Proposed Car Park Extension

Bersham Hall, Bersham Road, Wrexham

Our reference: LB/230585/TN01 – Rev06

Date: 09 August 2024

Drawing No.	SCP/230585/SK03
Rev.	-

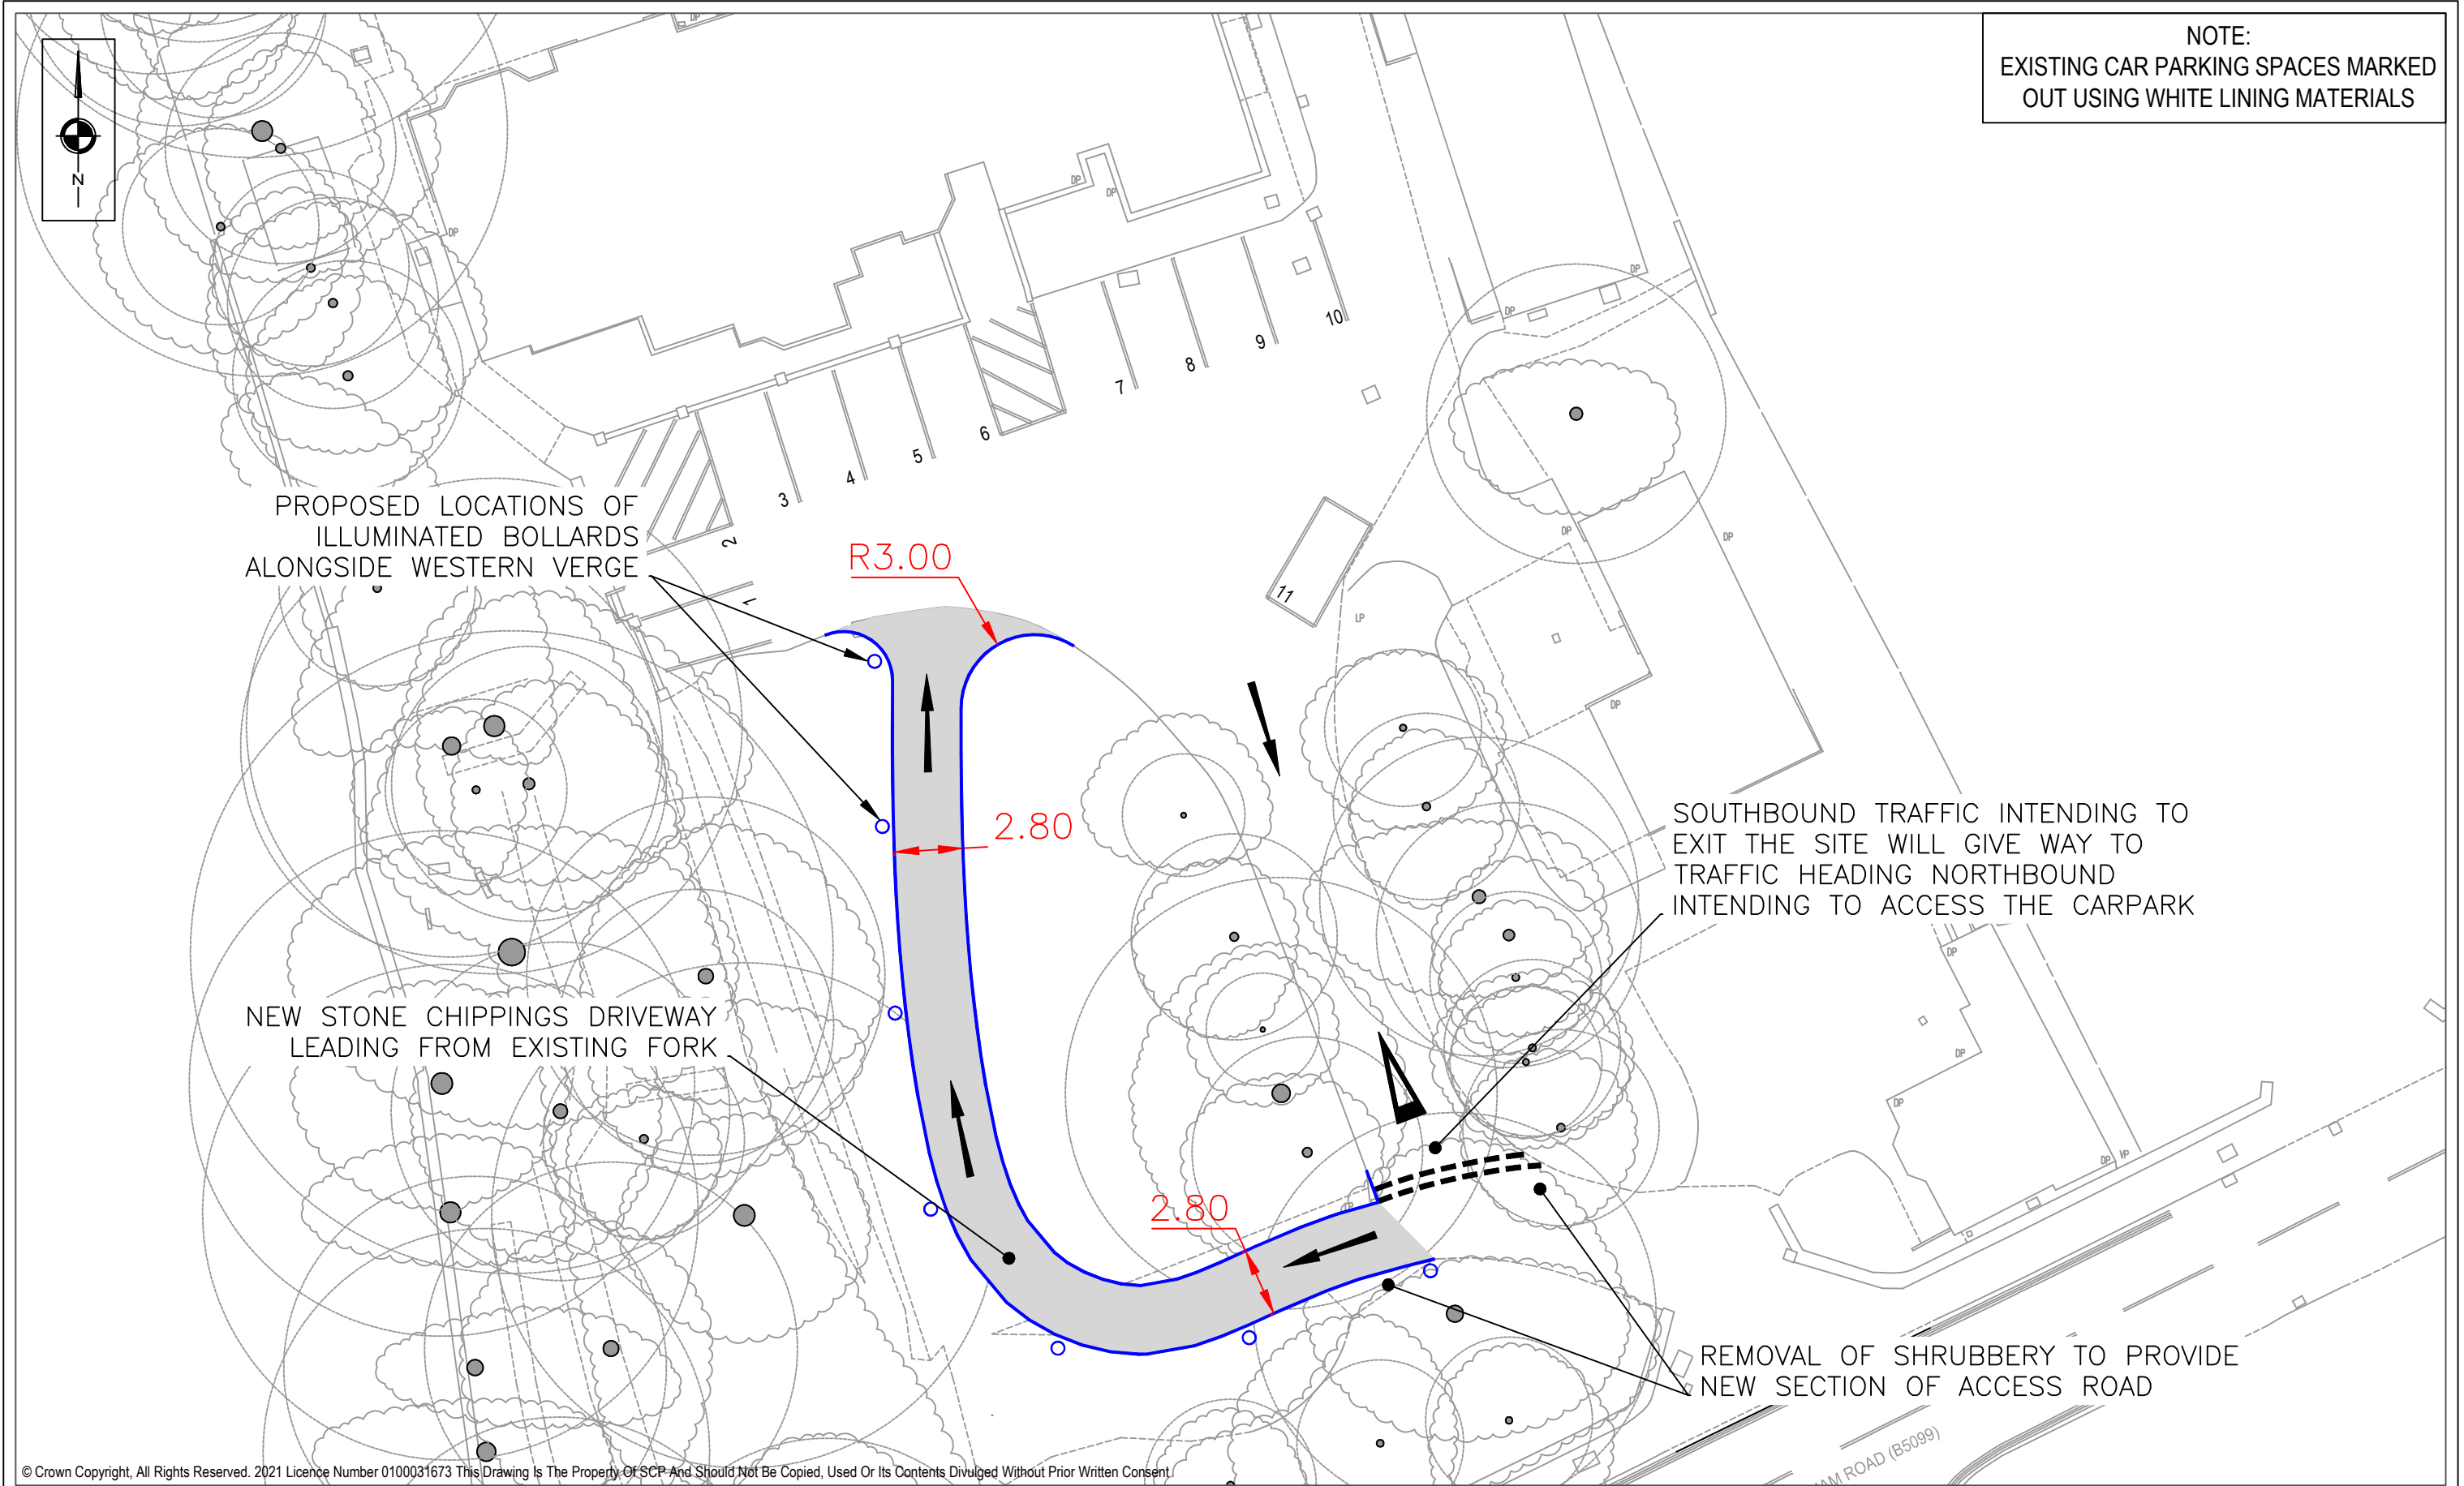
I understand that the applicant wishes to improve access and parking arrangements at the site by constructing an additional road / track just inside the entrance which links up to the existing hard standing / parking area fronting the school. This is intended to operate as a one way system into the site, exiting using the existing lane out. I understand that it is proposed to construct a limited number of parking spaces on the grassed area fronting the site and on part of the lawned area to the rear of the site.

I would recommend that the applicant submits a suitably scaled plan indicating the existing and proposed parking spaces (including turning areas) and the proposed new access track (one way system). The proposed access / parking arrangements would appear to offer a significant improvement over existing arrangements and may well reduce the potential for vehicles backing up at the entrance or parking on the adjoining highway.

I would recommend that any existing / proposed parking spaces are suitably marked out using white lining materials or similar. Give way markings on the internal exit lane would also be considered beneficial giving priority to those entering the site. Appropriate signage indicating the one way system would be beneficial.

- An internal one-way system will be provided between the existing car park and access along Bersham Road, as shown on drawing SCP/230585/SK03 provided in **Appendix G**. The proposed arrangement will allow two cars to pass one-another, encourage internal vehicular free flow and prevent queuing back to the access, Bersham Road and the internal parking area. It is proposed that southbound traffic intending to exit the site will give way to traffic heading northbound intending to access the car park in order to further prevent queuing back to the site access and Bersham Road. The proposed section of internal road will be surfaced in stone chippings and will include illuminated bollards for increase driver visibility. Cutting back of the existing shrubbery/vegetation will be required;
